Response to Engineering Items Raised in An Bord Pleanála, Fingal County Council and Dublin City Council Pre-Application Consultation Opinion Reports

Proposed Strategic Housing Development at Belcamp, Dublin 17

April 2022

Client Name: Gerard Gannon Properties
Document Reference: 19-114r.021
Project Number: 19-114

Figure 1 | Belcamp SHD - Phasing

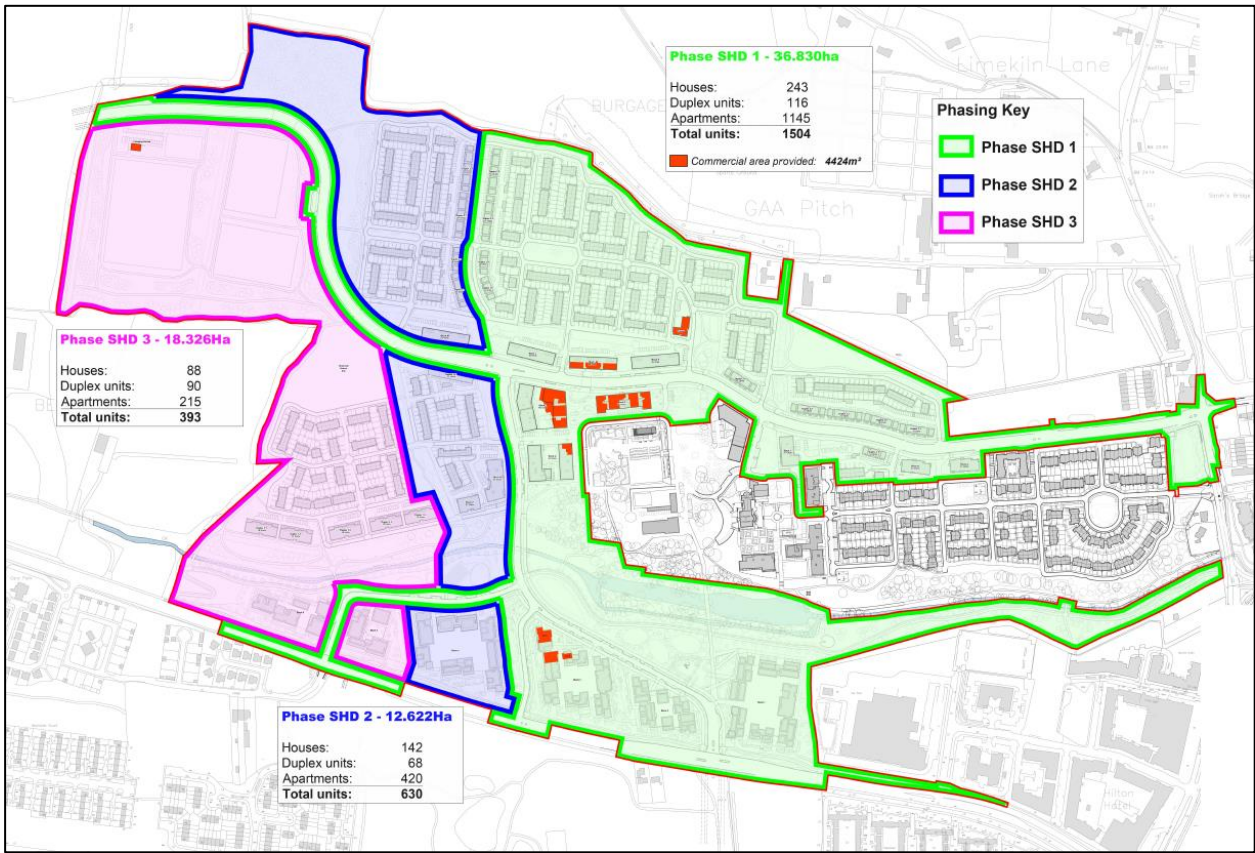
- *The proposed residential development should be linked to the provision of crucial strategic infrastructure and should be phased in accordance with the delivery of same. A similar process was undertaken for the Belmayne/Clongriffin lands.*

The proposed Belcamp development has been specifically designed to avoid a car dominated environment, and the proposed construction phasing includes the main internal transportation infrastructure as part of the first phase of development to ensure that there is adequate transportation provision in place before the development is occupied.

It is proposed to include the main internal transportation infrastructure as part of the first phase of development, including the EWLR, Belcamp Parkway and the Bus Gate. This will ensure that there is adequate transportation provision in place before the development is occupied. Refer to the Phasing Plan Figure included in Section 2.1, above.

Figure 3 | South Fingal Transportation Strategy

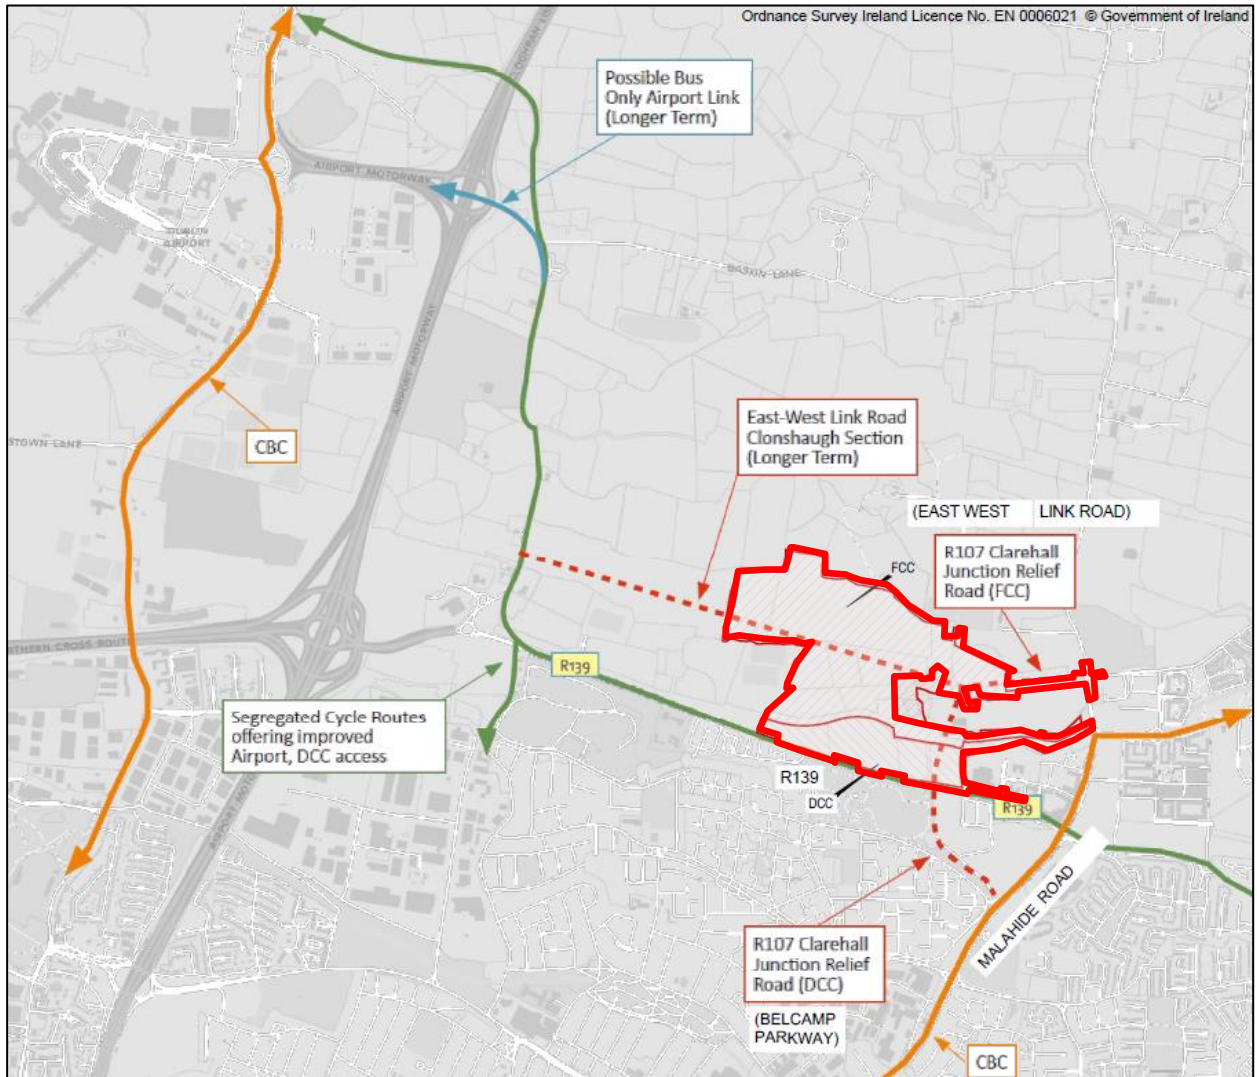
Further consideration and/or justification of the documents as they relate to the traffic and transport provision. The submitted documentation should address the requirements of the South Fingal Transport Study and the delivery of the East West Link Road. Regard should be given, in the Traffic and Transport Assessment, inter alia, the capacity of the surrounding junctions and the impact of the proposed development on the surrounding road network and the delivery of sustainable transportation options

A detailed review of the requirements of ***the South Fingal Transportation Study (SFTS) and the delivery of the EWLR*** is provided in Section 5.2 and 5.4.1 of the accompanying Engineering Assessment Report.

The main transport routes proposed through the subject site, as envisioned in the SFTS, are shown in the Figure below. This strategy is in accordance with the DCC and FCC Development Plans.

Figure 4 | Phasing plan for DCC Lands (from CCK Phasing Drawing)

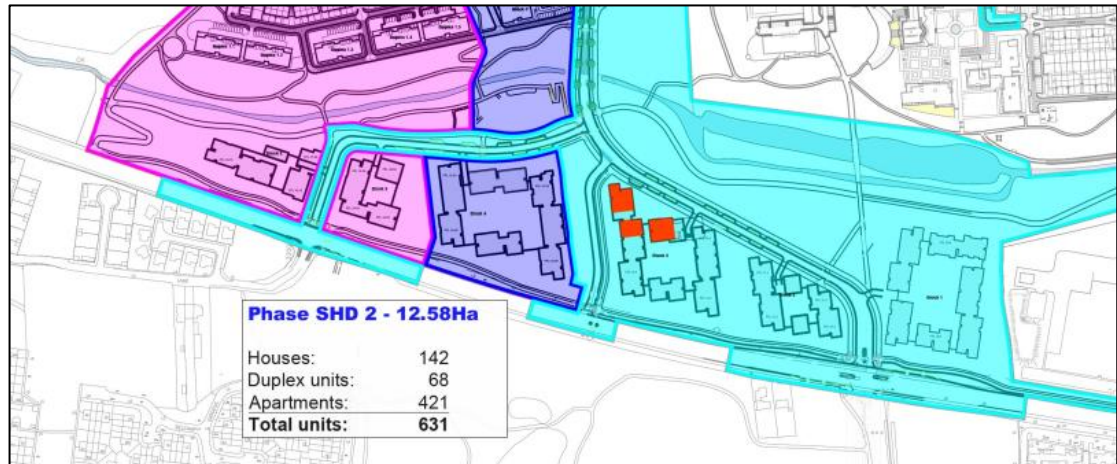
- **Detail of proposed phasing of surface water drainage works.**

The phasing for the site is as per the phasing drawing provided by Conroy Crowe Kelly Architects, see extract below.

The Cyan area is phase 1, Blue is phase 2, and Magenta is phase 3. The attenuation area is within phase 1, and subsequent phases follow logically behind so there is no issue with delivery.

Figure 5 | DCC Lands Surface Water Outfall Calculation (Appendix B, Engineering Assessment Report)

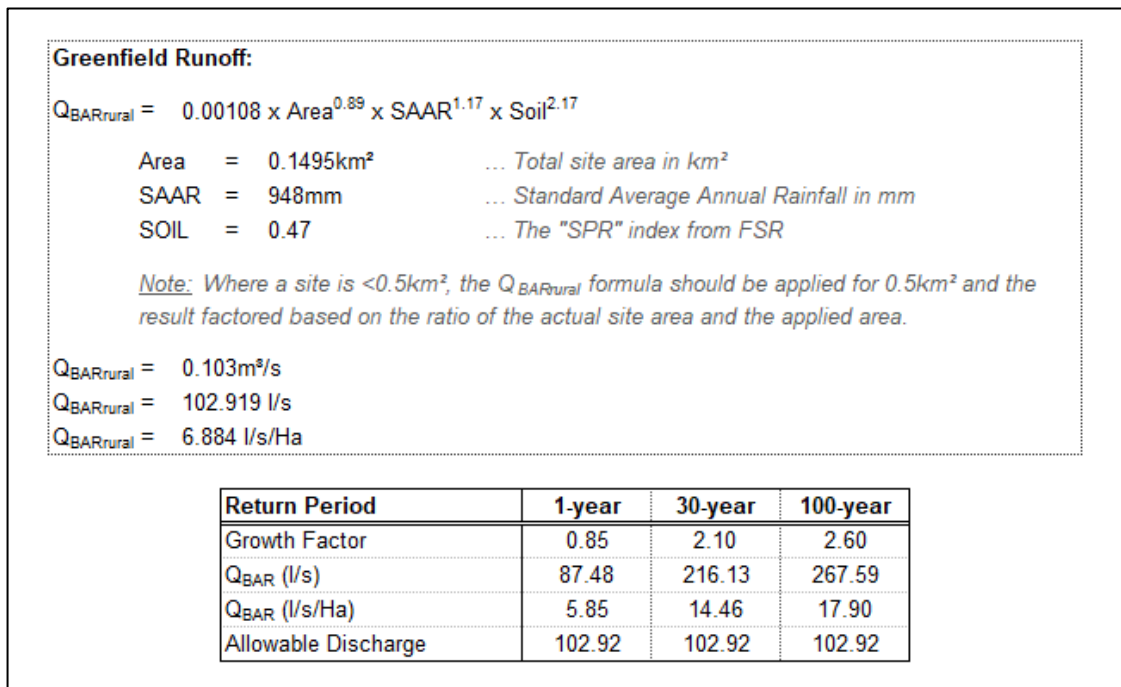
- **Detail of Surface water discharge rate agreed in consultation with DCC Drainage Division - Greenfield run off rate in accordance with the requirements set out in the Greater Dublin Strategic Drainage Study or two litres per second per hectare as current Policy of DCC Drainage Division shall be applied.**

The surface water discharge rate has been calculated in accordance with the GSDSDS, Criterion 4, River Flood Protection, wherein it is stated that runoff should be limited to either Qbar or 2 l/s/ha, whichever is the greater.

For the Belcamp site, there is extensive boulder clay and infiltration/soakaway tests have yielded no effective soil permeability. Waterman Moylan asked Site Investigations Ltd., who conducted all ground investigations for the site, to recommend an appropriate SOIL value. This was confirmed as a SOIL value of 4. The Qbar calculations below are from section 3 of the Engineering Assessment report, Appendix B.

From the above, The allowable outflow from the DCC lands with an area of 14.95 ha, with hardstanding of 32% and SOIL value 4, is calculated at 103 l/s.
